A30 Chiverton to Carland Cross

Subject: Response to CC comments on operational modelling of Carland Cross

Document Reference: HA551502-ARP-HGN-SW-FN-TR-000011

- 1.1.2 Following a review of these documents by CC have raised a query regarding the queue reported in the Operational Assessment technical note for the A39 approach at Carland Cross as this is low in comparison to the queue acknowledged to occur at this junction.

Figure 1: Carland Cross junction

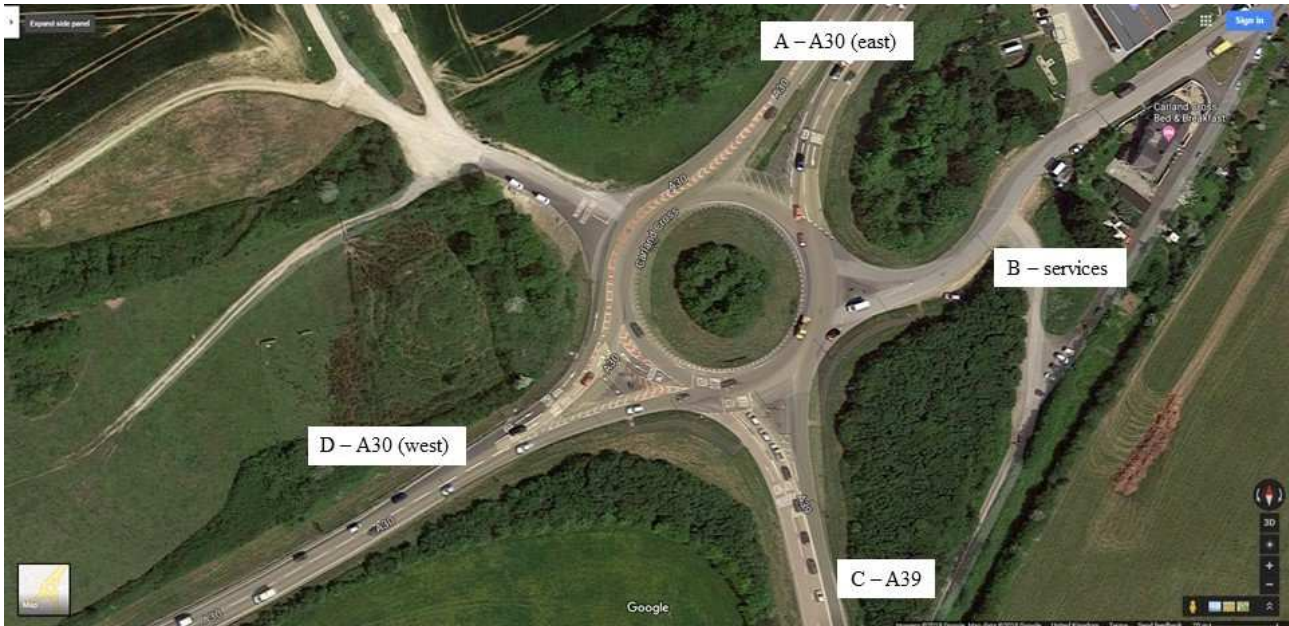
- 3.3.3 The data shows there are significant differences between the queues on the A39 between the PCF Stage 2 and Stage 3 models. The differences between the PCF Stage 2 and 3 assessments are due in part to the approach taken to model Carland Cross. Different approaches have been taken due to the unbalanced lane flows that occur on key arms of Carland Cross.

- 3.3.4 Carland Cross requires an alternative approach in order to account for the unbalanced lane usage that occurs on certain arms. This unbalanced lane usage occurs as a result of the traffic flows and lane markings.

issue with regards to the A39 arm as it is known that there are significant queues on this arm as a result of heavy traffic on the A30 travelling westbound creating capacity issues at the junction.

- 3.3.8 To address this issue an alternative methodology for modelling this junction has been applied in order to provide more robust and accurate results for this junction. Within the latest version of Junctions 9.5.0.6896 there is the opportunity to use a simulation mode that allows the user to model movements from individual lanes and thus deal with the issue of unequal lane usage.

- 3.4.2 Table 9 shows that utilising the lane simulation model results in queues on the A39 in 2015 that are closer to those observed and with delays that are close to those recorded from the journey time surveys and from Google directions.
